**GTEC** DOC. S.E. COD. SE-9APLBPF1-400B\_REV.01 PAG 1 / 6

OBJECT: SE LB400IGBTPF1 400k CABINET  
 EDITOR: F.MASTROPASQUA DATE: 13/06/2016 APPROVED: F.AMODEO  
 REPLACE: SE-9APLBPF1-400B\_REV.00  
 VARIATION: See page 6

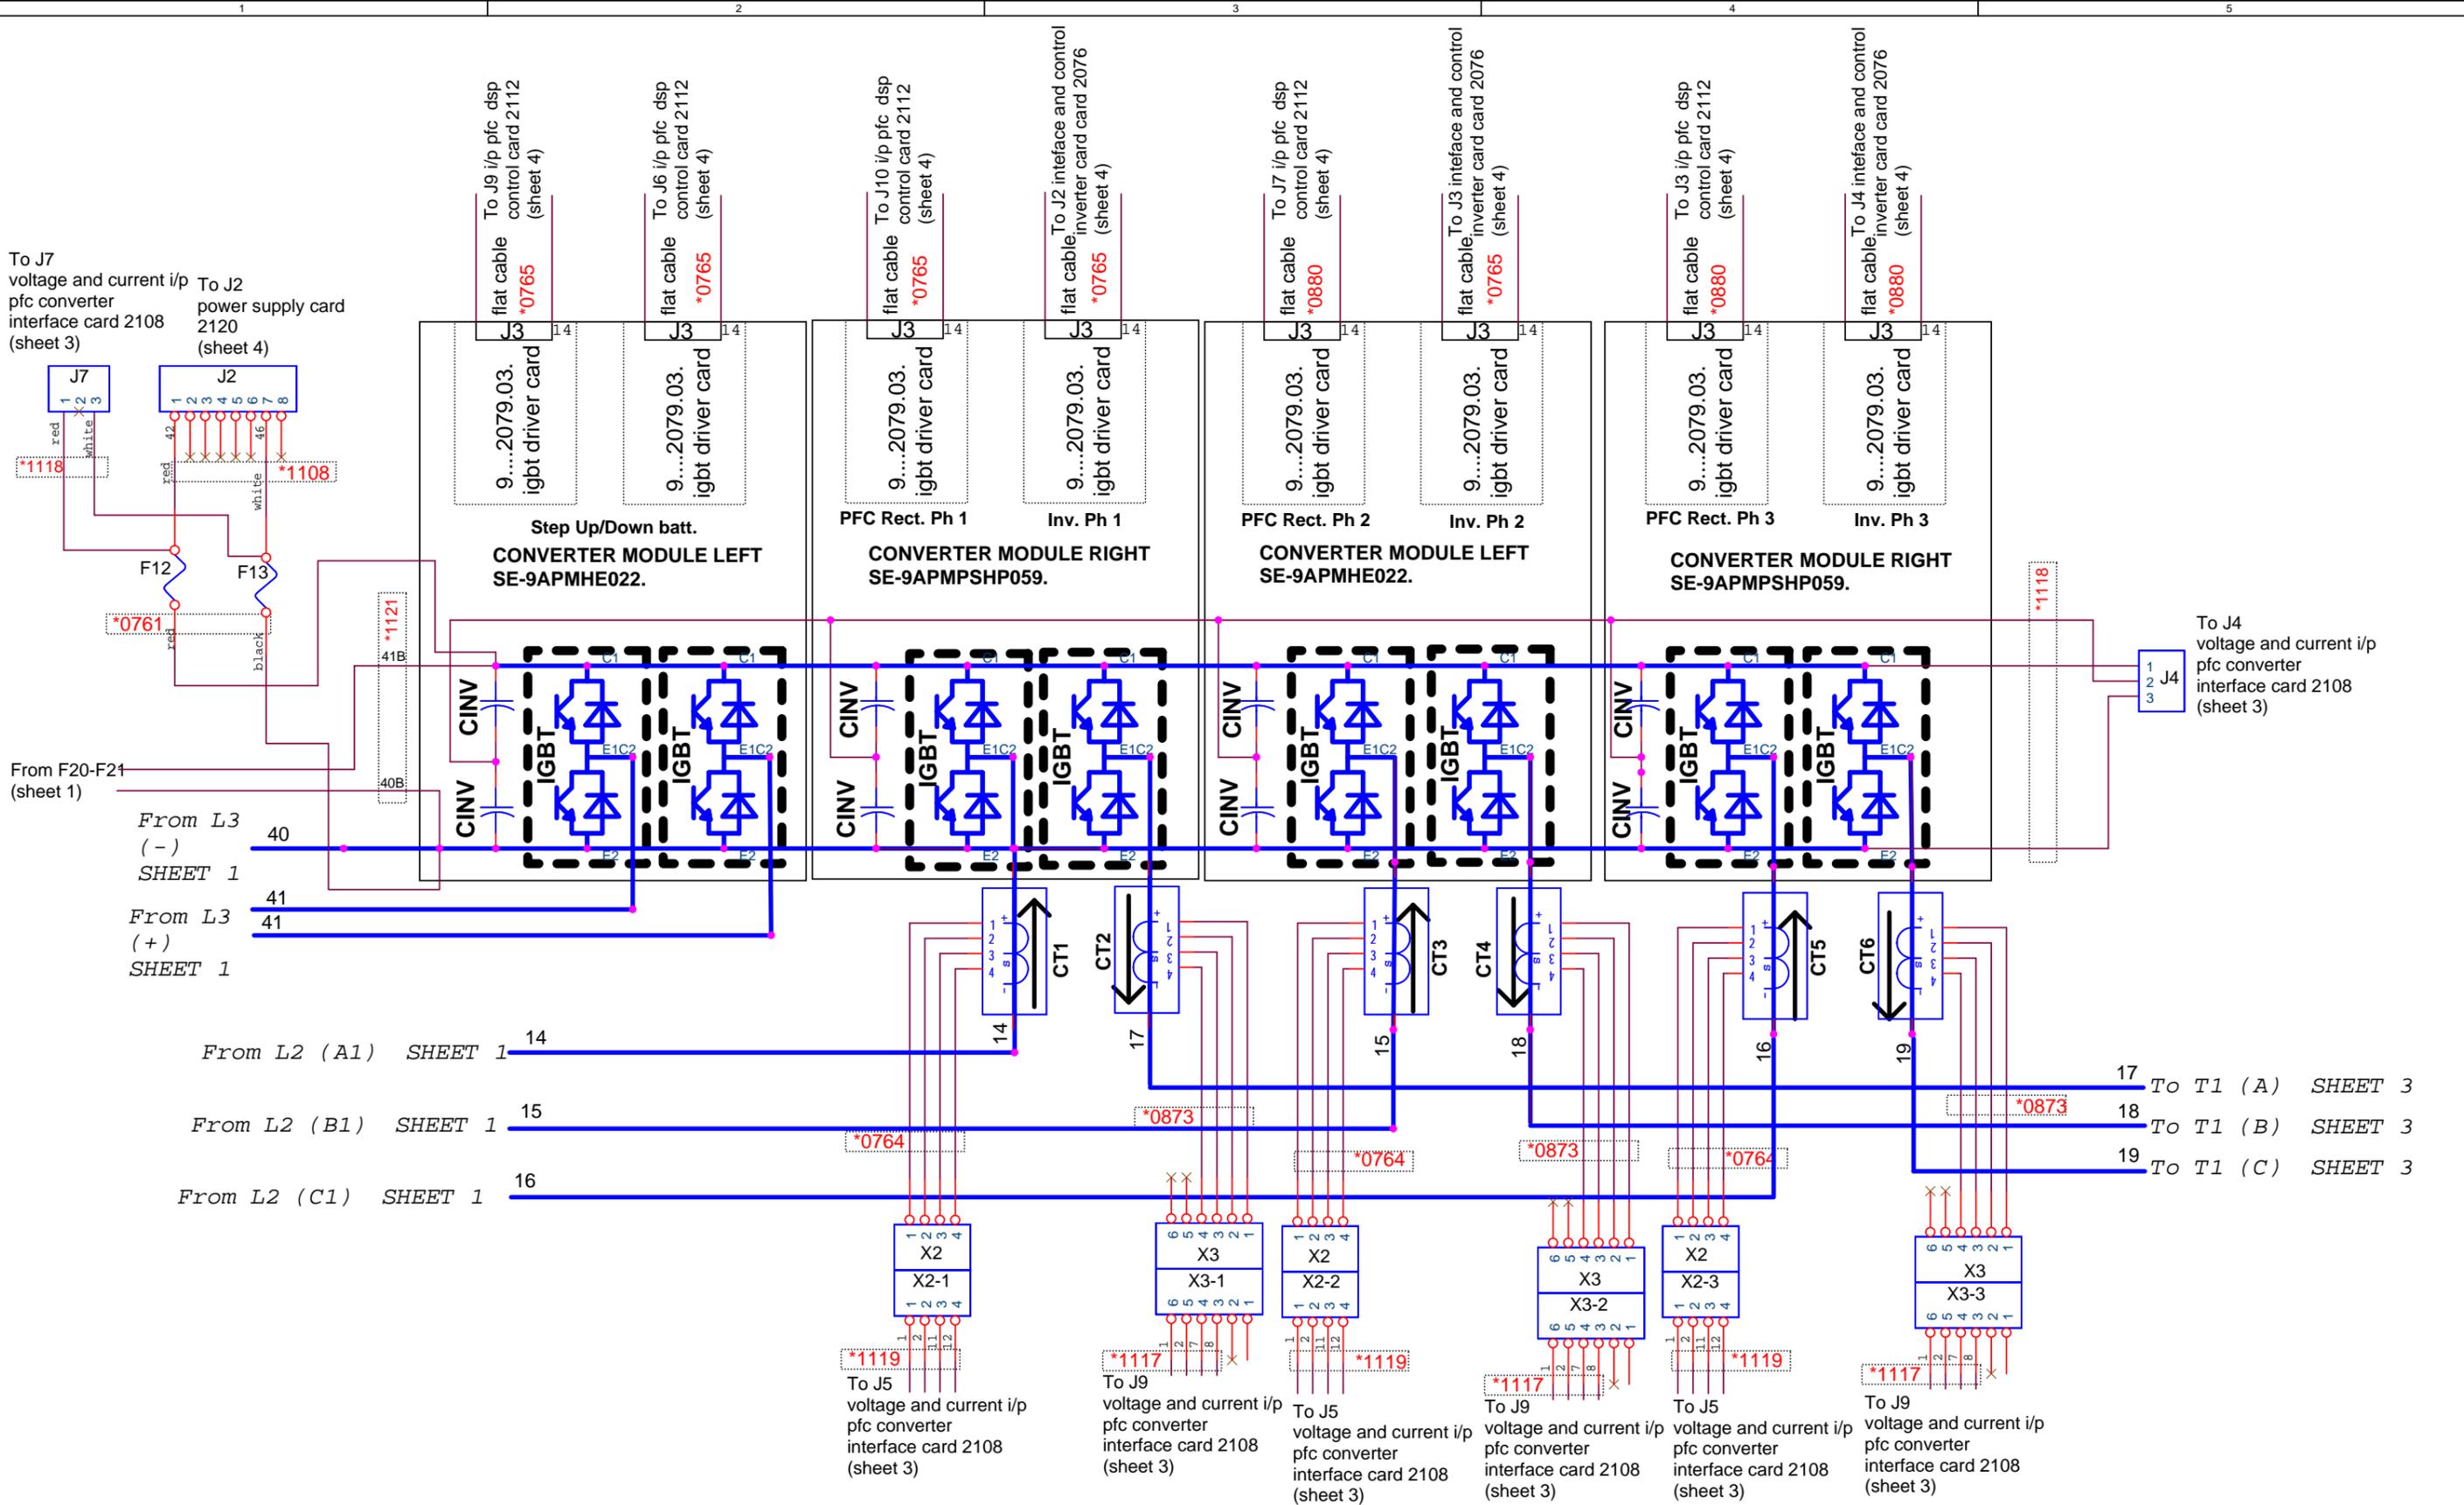
- 16/01/2015-From SE-9APLBPF1-400A\_REV.00 to SE-9APLBPF1-400A\_REV.01:  
-Cables to J7 2108 card modified position from from DC bus bar(Page 2) to fuses F12-F13(Page 2).  
-Replaced filter 9APMPS274. with card 9...2137.02. on interface I/O option (page 5).
- 03/03/2016-From SE\_9APLBPF1-400A-REV.01 to SE\_9APLBPF1-400B\_REV.00:  
-Add fuse F22-F23-F24(sheet 1)  
-Replaced code of card 2077 and insert card 9..2142.05.(sheet 1)  
-Add card 9..2137.01.(sheet 4)
- 13/06/2016-From SE-9APLBPF1-400B\_REV.00 to SE-9APLBPF1-400B\_REV.01  
-Add cable 0CBSA0452A(sheet 1)
